# PERMIT

SEWAGE DISPOSAL SYSTEM

MARYLAND STATE DEPARTMENT OF HEALTH

SUBDIVISION Pembroke Knolls ROAD Pindell School Rd. LOT 8, Sec. 2  
6958  
1/2 mile from Rt. 32 - right hand side

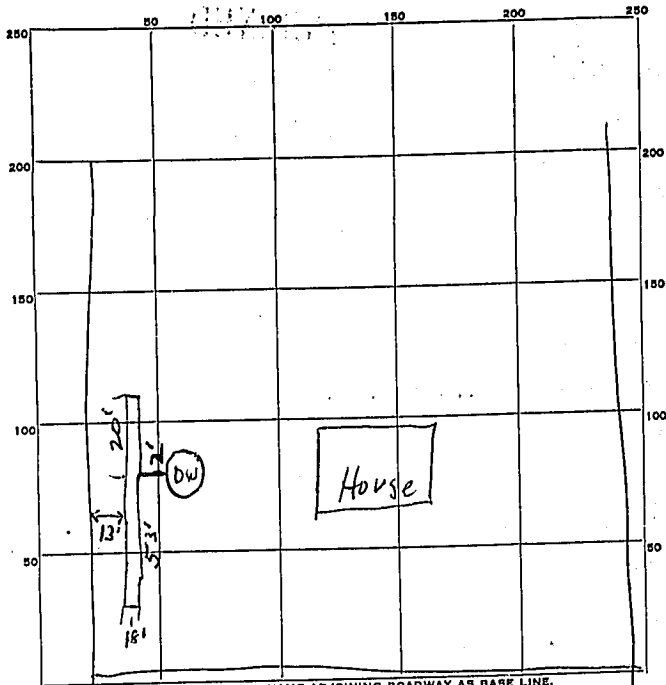
OTHER REPAIR - ~~XXXXXX~~ drain field to be added to dry well  
for overflow of wash water.

Mr. Kilmore saw ditch which was 72 ft. long and approved.

The 53 ft. section of drainage ditch shall be deep enough  
to accommodate 3 ft. of gravel under the distributor pipe. - JHK
